Addendum No. 3

Project: **Beaumont Independent School District New Transportation Center**

Date: **October 23, 2024**

All bidders/proposers are herewith notified of the following additions, deletions, changes or clarification to the drawings dated August 23, 2024, and shall be acknowledged as received on the proposal form.

10 EXTERIOR PIPE MOUNTING DETAIL
SCALE: NONE

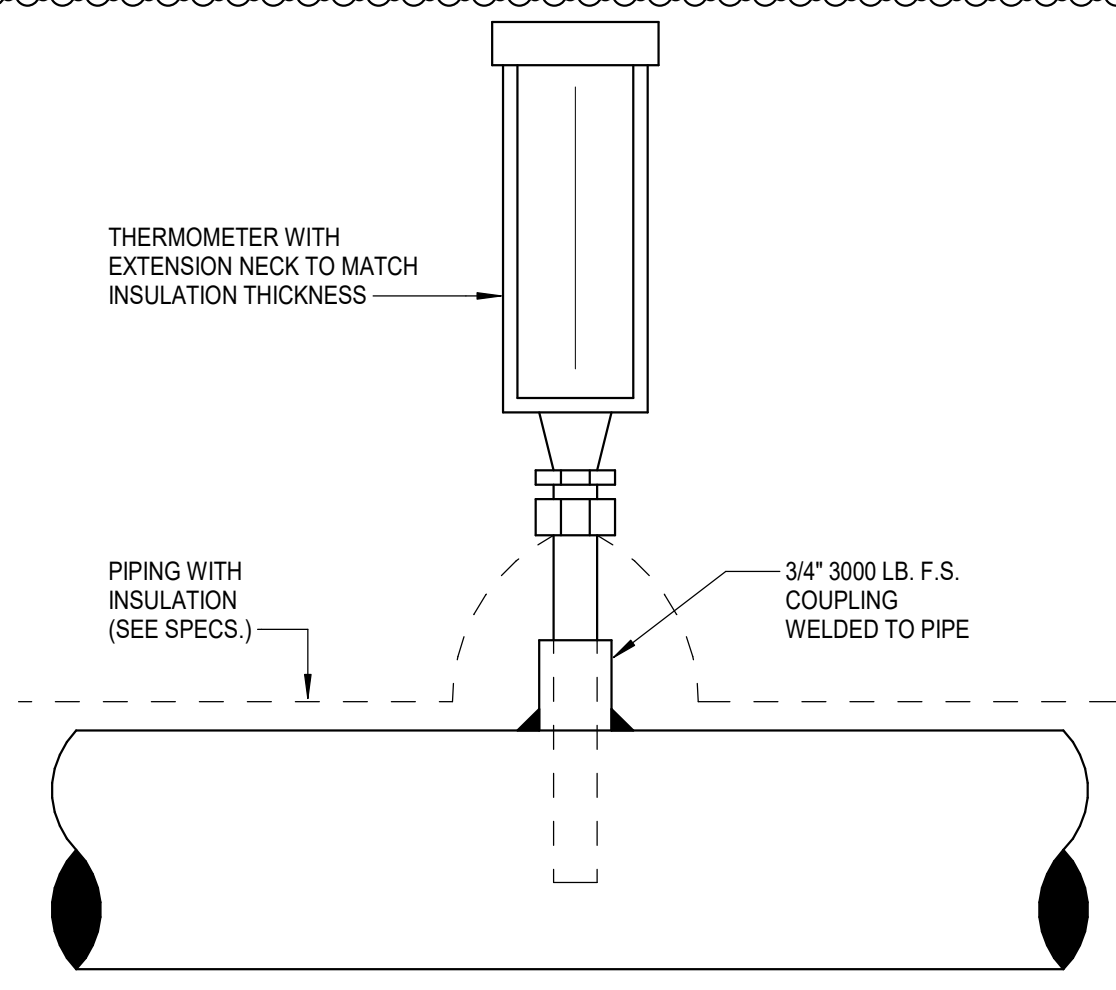
10. SHEET M401 – MECHANICAL DETAILS AND LEGENDS
 - a. Add detail #10 EXTERIOR PIPE MOUNTING DETAIL.
 - b. Replace sheet in its entirety.
11. SHEET M500 – MECHANICAL SCHEDULES
